FEDERAL AVIATION AGENCY

# Airworthiness Directives

Effective January 1, 1963

Part 507 of Regulations of the Administrator

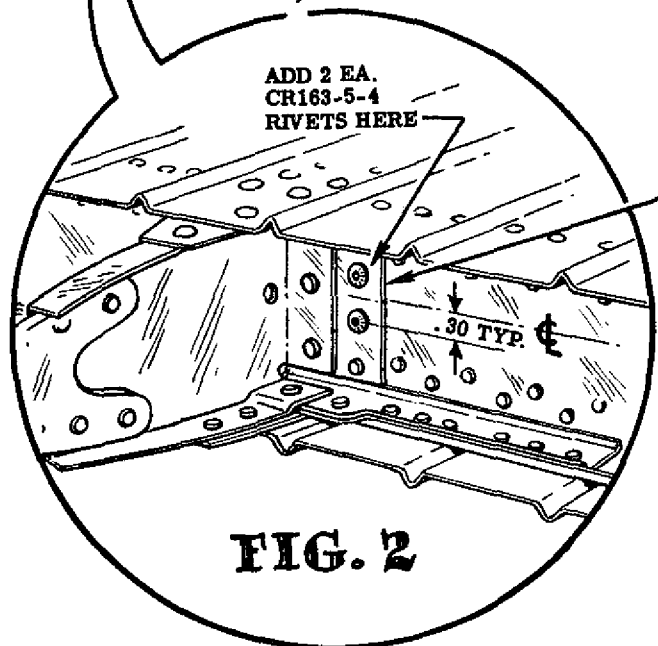
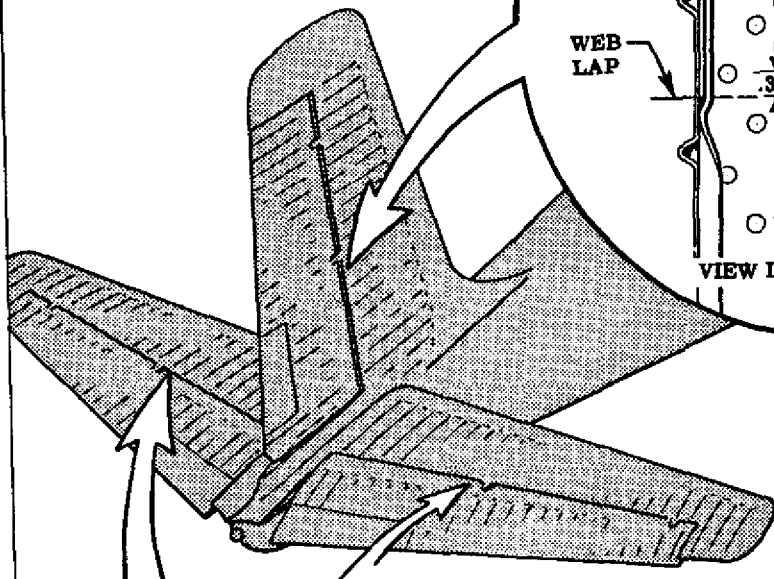
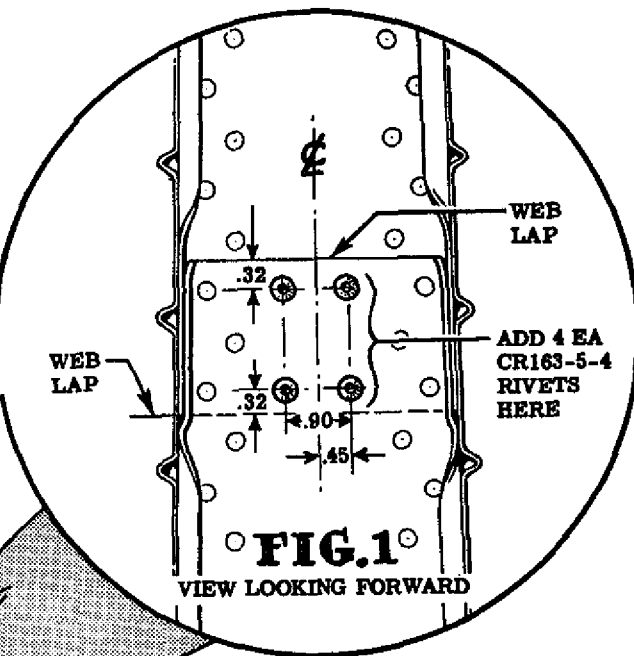
(1) *Vertical Stabilizer—Rear Spar*—In the locations shown in Figure 1 drill four holes using a number 20 drill bit and install four cherry rivets, P/N CR163-5-4.

(2) *Horizontal Stabilizer—Rear Spar*—In the locations shown in Figure 2 install two CR163-5-4 rivets on each stabilizer. In the event the spar web lap extends less than  $\frac{1}{2}$ -inch inboard of the forward flange on the center hinge bracket (see Figure 2) the Service Department, Aero Design and Engineering Company, Bethany, Oklahoma, should be contacted for instructions for installation of a spar web doubler.

FIGURE 1

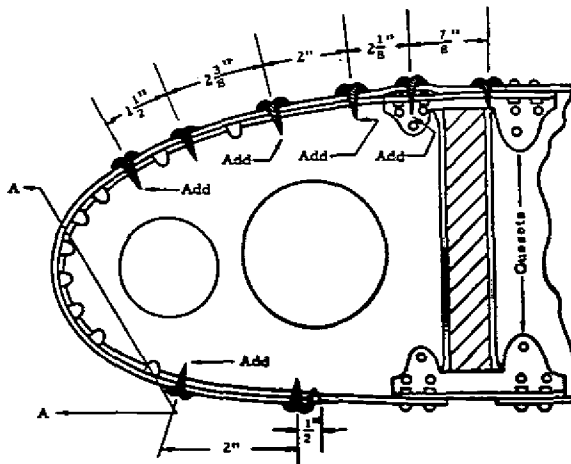
Inspect the wing leading edge for buckled nose ribs or loose PK screws by pressing leading edge skin with hand to nose ribs. If the skin can be depressed beyond the normal wing contour, other than the extreme nose radius, indicated by section A-A in Figure 1, the fabric should be cut open on the bottom surface

occurred or not, whereas item No. 2 pertains only to damaged ribs found in the above inspection. Repair need not be made if buckling is confined to area forward of section A-A of Figure 1.

1. To help prevent further failures of the nose ribs five additional No. 4 x 1/4 PK screws or, as an alternate, Cherry CR163-4-2 rivets or equivalent are to be installed in all nose ribs. Four PK screws or rivets are to be installed on the top surface and one PK screw or rivet is to be installed in the bottom as shown in Figure 1. Apply dope liberally under the PK screw head before tightening. It is not necessary to remove the fabric to accomplish this modification.

2. Damaged ribs should be cut away at the top and bottom of spar. The new nose ribs are installed by means of two gussets on the side of the ribs as shown in Figure 1. Factory kits, Aeronca P/N 5-185-2 and 5-190-2, are to be used.
